CITY PLAN COMMISSION**THURSDAY, MARCH 23, 2023****FILE NUMBER:** S223-090**CHIEF PLANNER:** Mohammad H. Bordbar**LOCATION:** Singleton Boulevard, between Borger Street and Crossman Avenue**DATE FILED:** February 23, 2023**ZONING:** CR**CITY COUNCIL DISTRICT:** 6 **SIZE OF REQUEST:** 0.967-acres**MAPSCO:** 44P**APPLICANT/OWNER:** FWLB Singleton, LP

REQUEST: An application to replat a 0.967-acre tract of land containing all of lots 1 through 6 in City Block 2/7108 to create one lot on property located on Singleton Boulevard, between Borger Street and Crossman Avenue.

PRELIMINARY PLAT

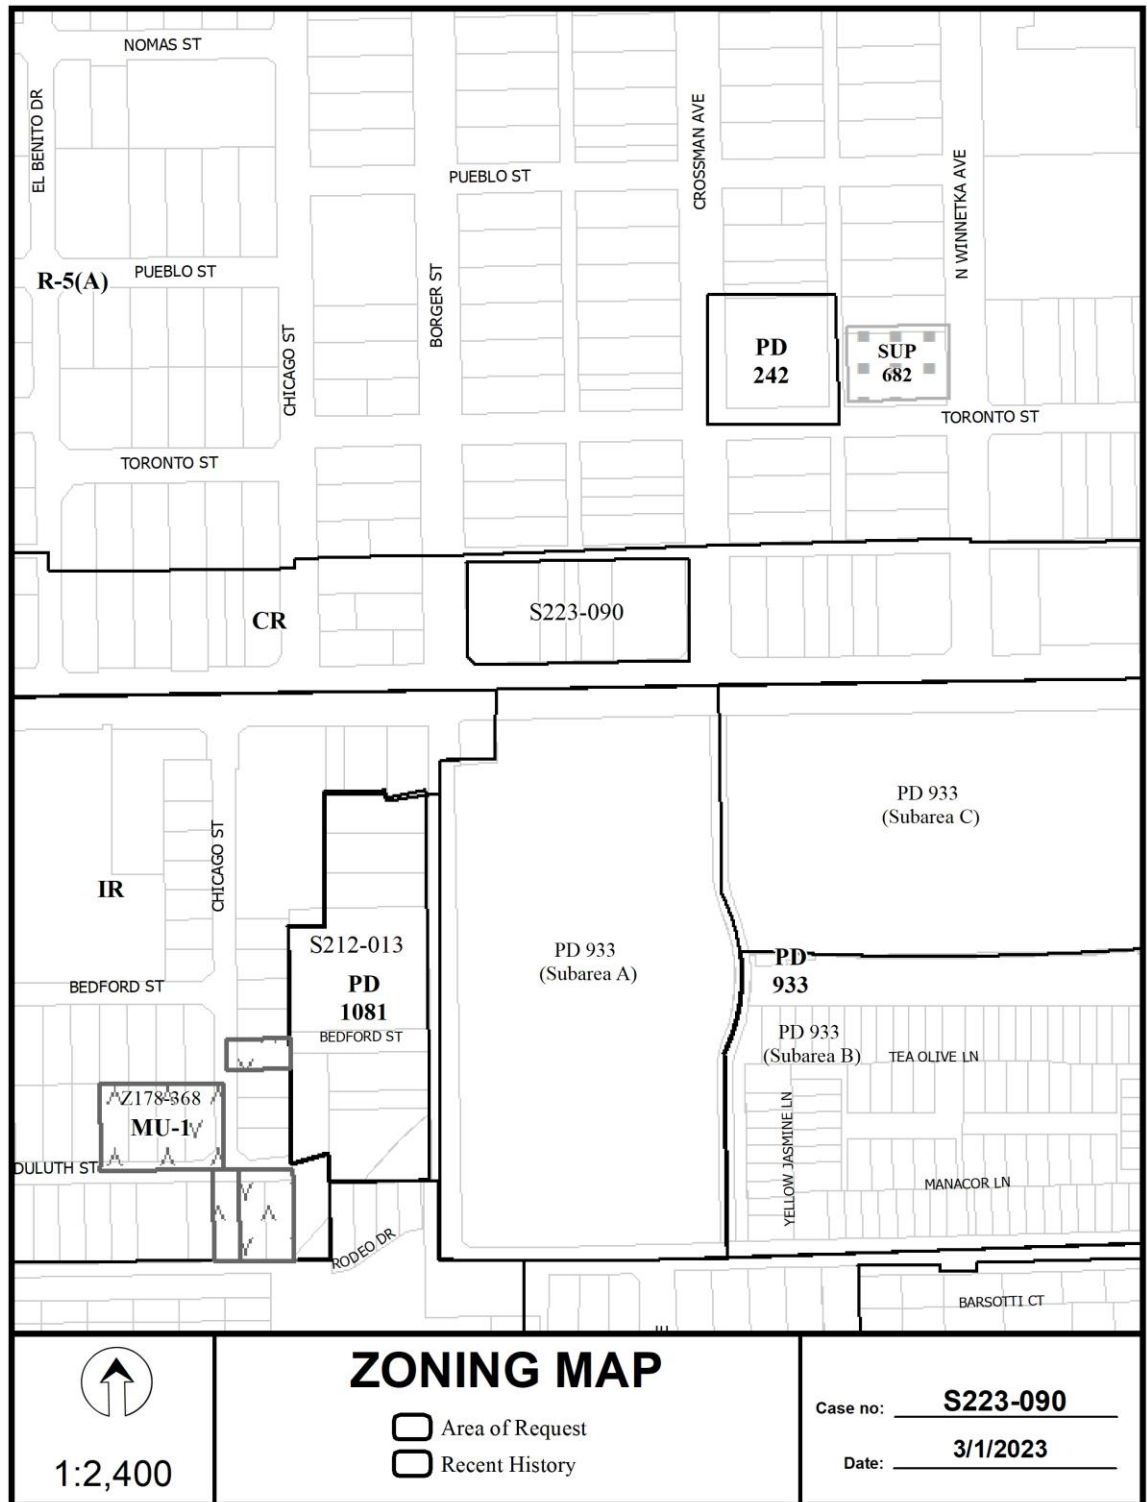
15. On the final plat, dedicate 50-feet of right-of-way (via fee simple) from the established center line of Singleton Boulevard. *Section 51A 8.602(c)*

16. On the final plat, dedicate a minimum 10-foot by 10-foot corner clip (via fee simple or street easement) at the intersection of Singleton Boulevard and Crossman Avenue. *Section 51A 8.602(d)(1)*

17. On the final plat, dedicate a 15-foot by 15-foot Alley Sight Easement at the intersection of Borger Street and the alley. *Section 51A-8.602(e)*
18. On the final plat, dedicate a 15-foot by 15-foot Alley Sight Easement at the intersection of Crossman Avenue and the alley. *Section 51A-8.602(e)*

20. Prior to final plat, submit a completed final plat checklist and all supporting documents.
21. On the final plat, show recording information on all existing easements within 150 feet of the property.
22. On the final plat, show all additions or tracts of land within 150 feet of the property with recording information. Platting Guidelines.

26. On the final plat, add a label for (F.K.A. Patrick Street) to Borger Street south of Singleton Boulevard. Section 51A-8.403(a)(1)(A)(xii)
27. On the final plat, identify the property as Lot 1A in City Block 2/7108. Ordinance 1A, Page 131 pages 131-148, Section 2 (passed August 13, 1872).
